STATE OF NORTH CAROLINA
DEPARTMENT OF TRANSPORTATION

Subject: **Revised Permit Drawings and Calculations** for Improvements to SR 1733 (Weaver Dairy Road), from NC 86 (Martin Luther King, Jr. Boulevard) to SR 1734 (Erwin Road) Chapel Hill, Orange County, Division 7, Federal Aid No. STP-1733(11); State Project 8.2501601, TIP No. U-3306.

Reference: NCDOT Section 404 and Section 401 Individual permit application (March 25, 2009)

REVISED 7/28/09
Permit Drawing
Sheet 9 of 13

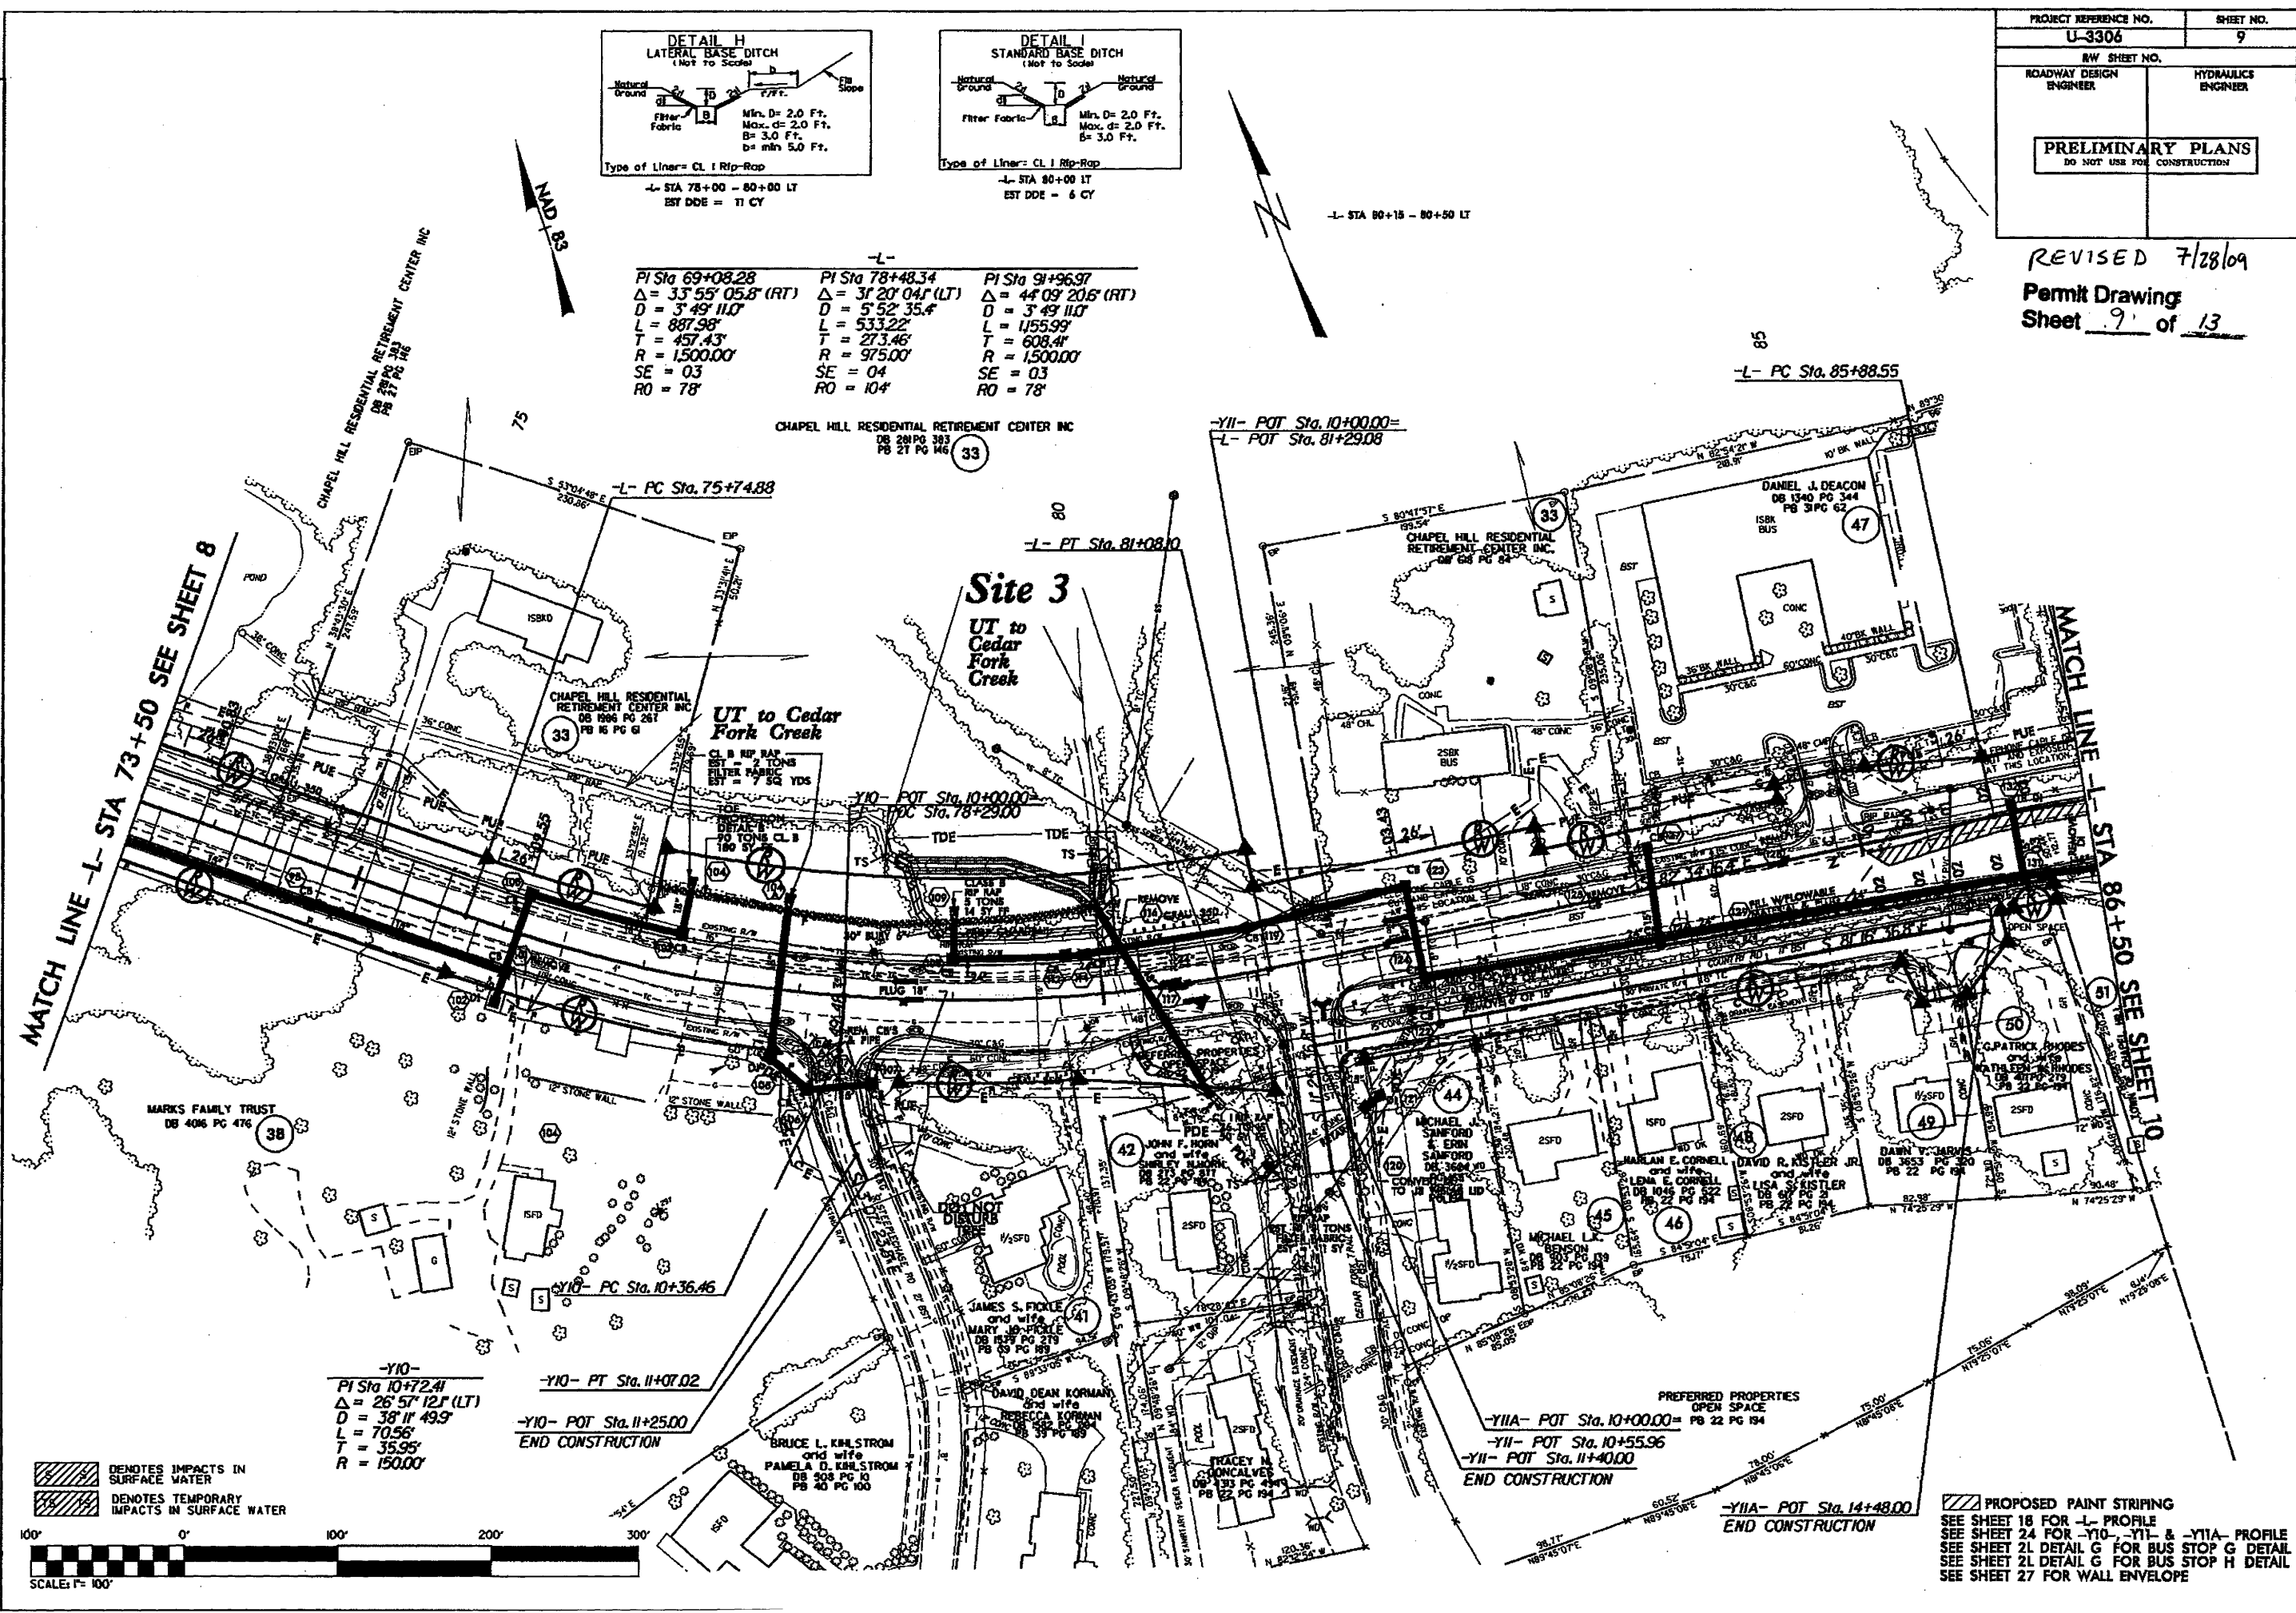
Enclosed are the calculations and the revised permit drawing sheets you requested. The hydraulic calculations show that rip rap was needed on the stream banks at Site 3 and revised drawings for Site 3 showing rip rap along the sides of the stream and not in the stream channel.

Type of Liner = CL I Rip-Rap
-L- STA 78+00 - 80+00 LT
EST DDE = 11 CY

Type of Liner = CL I Rip-Rap
-L- STA 80+00 LT
EST DDE = 6 CY
